SUBDIVISION REVIEW SHEET

CASE NO.: C8-2020-0188.0A

SUBDIVISION NAME: 1940 Webberville Road

CITY OF AUSTIN –DEVELOPMENT SERVICES DEPARTMENT
SUBDIVISION APPLICATION – MASTER COMMENT REPORT

Exhibit B: Proposed plat

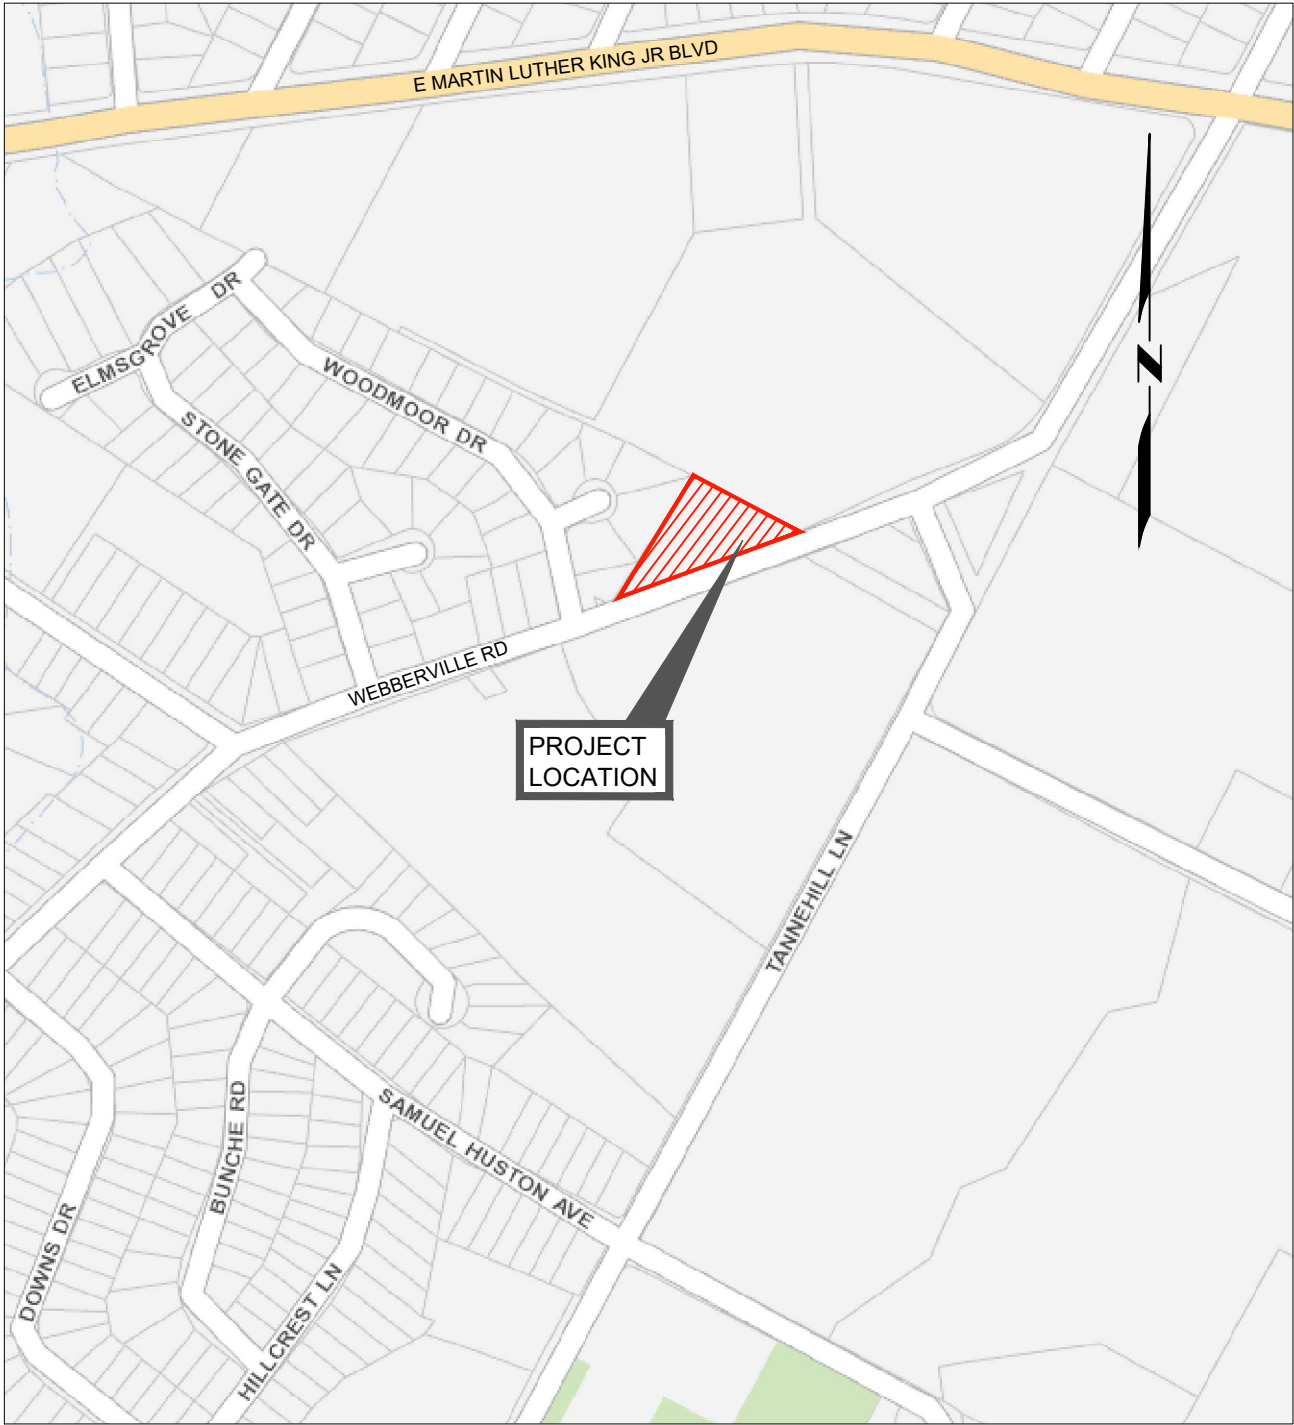
Fifteen foot electric distribution, electric telecommunications, and electric fiber easement is required adjacent to street R.O.W. along Webberville Rd and along western lot line of this site to protect existing overhead electric facilities. Show the easement(s) on the face of the plat.

Ten foot electric distribution, electric telecommunications, and electric fiber easement is required along the eastern lot line of this site. Show the easement(s) on the face of the plat.

ATD 1. A joint-use driveway used as alternative access for a single-family residential use may serve not more than eight dwelling units. LDC 25-6-451(C). Provide a plat not restricting the number of dwelling units accessing the single joint use access easement driveway.

ATD 3. Show a survey tie across all existing streets bordering or traversing this subdivision and show the entire right-of-way for Webberville Rd. to verify right-of-way width. LDC 25-4-131.

ATD 4. Please remove "for street purposes" from the label in the hatched dedication area.

- SR 1. Update the lot summary table to include lot acreage, square footage and totals, also include the right-of-way dedication on the table. 25-1-83
- SR 2. Remove the 25 foot setback line from inside the lots. 25-1-83

- SR 3. Include clear annotation for the drainage easement area with arrows demonstrating the boundaries of the easement. 25-1-83
- SR 4. Verify that the scale on the plat measures correctly. 25-1-83

- SR 5. Delete notes #3, #7 and #13. 25-1-83
- SR 6. If fiscal is required replace Note #11 with the following note. 25-1-83, 25-4-38, 25-4-84 or 30-1-113, 30-2-38, 30-2-84
"This subdivision plat was approved and recorded before the construction and acceptance of streets and other subdivision improvements. Pursuant to the terms of a Subdivision Construction Agreement between the subdivider and the City of Austin, Dated _____, 20__, the subdivider is responsible for the construction of all streets and facilities needed to serve the lots within the subdivision. This responsibility may be assigned in accordance with the terms of that agreement. For the Construction Agreement pertaining to this subdivision, see the separate instrument recorded in Doc#. _____, in the Official Public Records of _____ County, Texas."

- SR 7. Verify if notes #23, 24 and 25 are applicable to the plat, contact the City of Austin Transportation Department reviewer to determine if the notes are needed on the plat. 25-1-83

- SR 8. Revise the owner's dedication block as follows: 25-1-83 (or 30-1-113) and TX LGC 212.004(c)
That (owner) being the owner of that certain (acreage) tract of land out of the (survey/abstract) situated in _____ County, Texas, as conveyed by deed as recorded in Document No. (XX) of the official public records of _____ County, Texas, does hereby subdivide (XX) acres of land in accordance with the attached map or plat shown hereon, pursuant to Chapter 212 of the Texas Local Government Code, to be known as:

SR 9. Provide the printed name of the person that will be signing the plat. 25-1-83

SR 10. Revise the Land Use Commission approval block as follows 25-1-83 (or 30-1-113):

SR 11. Remove the City Council approval block. 25-1-83

SR 12. Insert the following note above the City of Austin approval block:

SR 13. Please revise the following administrative approval block: 25-1-83, 30-1-113

SR 14. Modify the recordation block as shown: 25-1-83, 30-1-113

SR 16. Add Case # in the bottom right hand corner of each sheet, C8-2020-0188.0A . 25-1-83 or 30-1-113
